January 18, 2017

Subject: Assessment of Impacts to Trees
1208 Saint Charles Street, Alameda, CA

Photo 1. Tree #2 was in good condition with a long lateral limb that extended out into the yard (arrow).

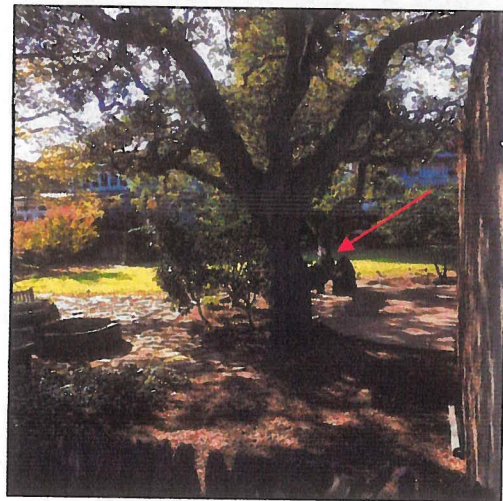
The oaks were mature with diameters of 36" and 33", respectively. Both oaks were in good condition, with full crowns and spreading forms. Oak #2 had a long lateral limb extending out to the east and held up by a prop (Photo1). Both trees had been over pruned and lion tailed within the past year. Lion tailing is a form of pruning that greatly reduces the green foliage, leaving growth only at the ends of each branch. Lion tailing is particularly detrimental to coast live oaks because they are susceptible to sunscald and sunburn.

Photo 3, right. Looking into the trench adjacent to tree #1.

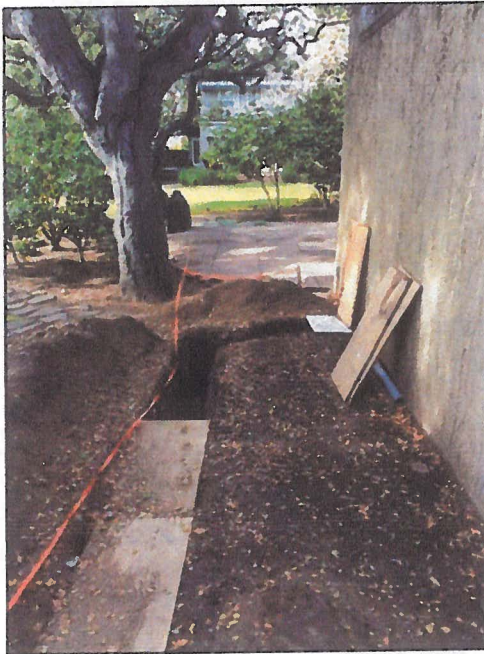
The trench adjacent to tree #1 had five roots larger than 2" that can be seen in Photo 3. I do not recommend any work be done in this area, cutting of roots this large and this close to the tree has the potential to impact health, compromise stability.
